METROPOLITAN GOVERNMENT OF NASHVILLE AND DAVIDSON COUNTY

STAFF RECOMMENDATION
2216 29th Avenue South
July 17, 2013

Application: New construction—addition and outbuilding
District: Hillsboro-West End Neighborhood Conservation Zoning Overlay
Council District: 18
Map and Parcel Number: 10414009500
Applicant: David Baird
Project Lead: Melissa Baldock, melissa.baldock@nashville.gov

BUILDING ELEVATIONS

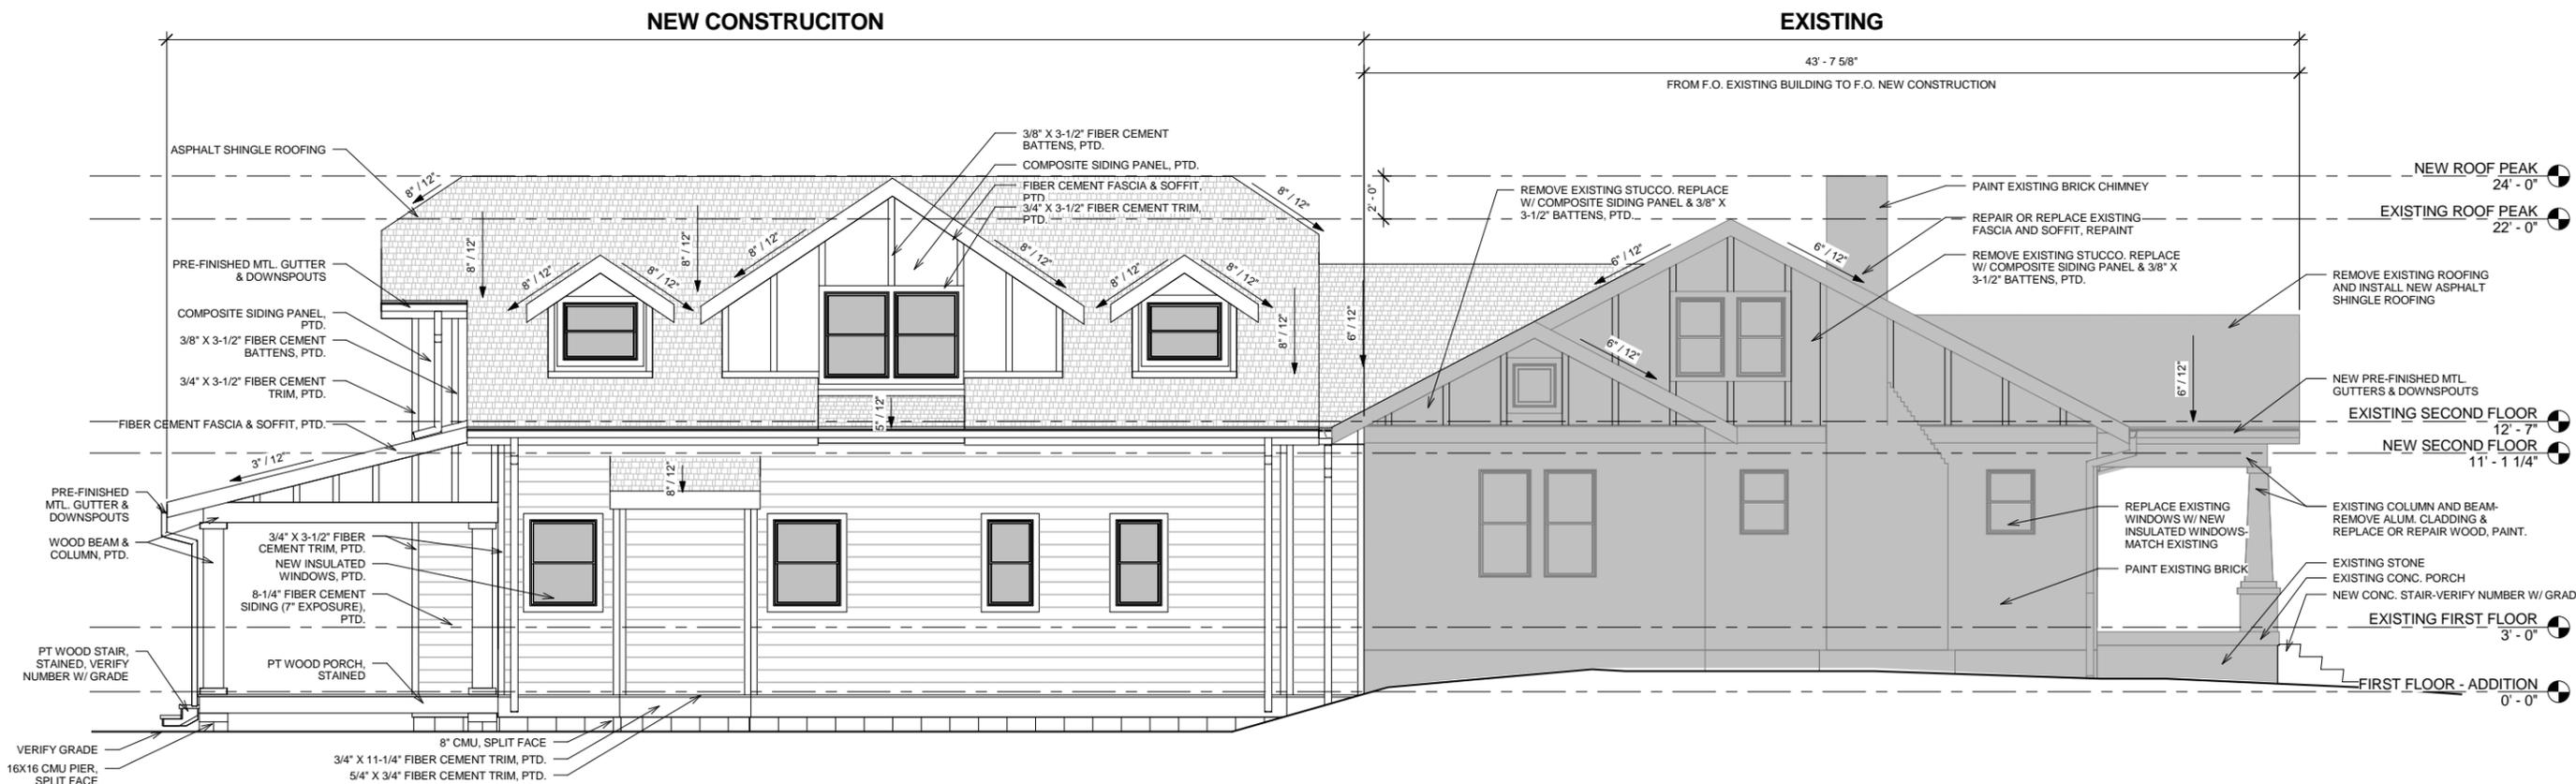
The addition will be clad in cement fiberboard. The drawings indicate that the siding will have a reveal of seven inches (7"), and staff asks that the siding have a maximum reveal of five inches (5"), as has been required for all past projects. Cement fiberboard trim will be used throughout the addition. The foundation will be split face concrete block, and the roof will be asphalt shingle. Staff asks to approve the asphalt shingle color. The dormers and rear gable will be clad in cement fiber board-and-batten. The porch will be stained wood. The materials for the windows and doors were not specified, and staff asks to approve all window and door materials and specifications prior to purchase and installation. With the above-mentioned staff approvals of materials, staff finds that the proposed materials meet Sections II.B.1.d. and II.B.2. of the *Hillsboro-West End Neighborhood Conservation Zoning Overlay: Handbook and Design Guidelines*.

3. The siding exposure have a maximum of a five inch (5") reveal; and
4. Staff review and approve the asphalt shingle color and all windows and doors prior to purchase and installation.
